Commissioning and Acceptance Radiation Protection Report

Employer:	AMDS	Date of assessment:	31 st January 2024
Facility:	Mobile CT unit "CT23"		
Location:	Tested at Lamboo Medical, Haydock, St Helen's		
Equipment Make	GE		
Equipment Model	Revolution EVO		
and System No.:	SN: CBDGG2300081HM		
Tube Details:	GE MX200CT III Tube (SN: 119483BA6)		
Local contact(s):	Jill Mckenna, Head of Imaging & Operations

RADIATION PROTECTION AND PERFORMANCE REPORT

Figure A2. IDRs (in $\mu\text{Sv/hr}$) measured through the door to the patient lift in the slide-out.

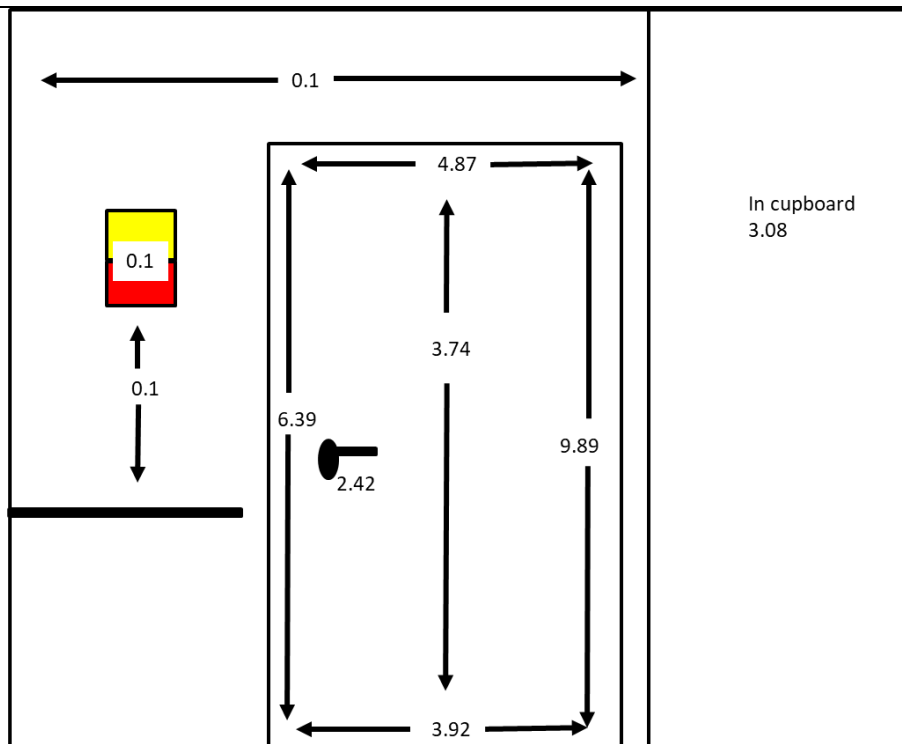
3.86 $\mu\text{Sv/hr}$ at 1 m from the door
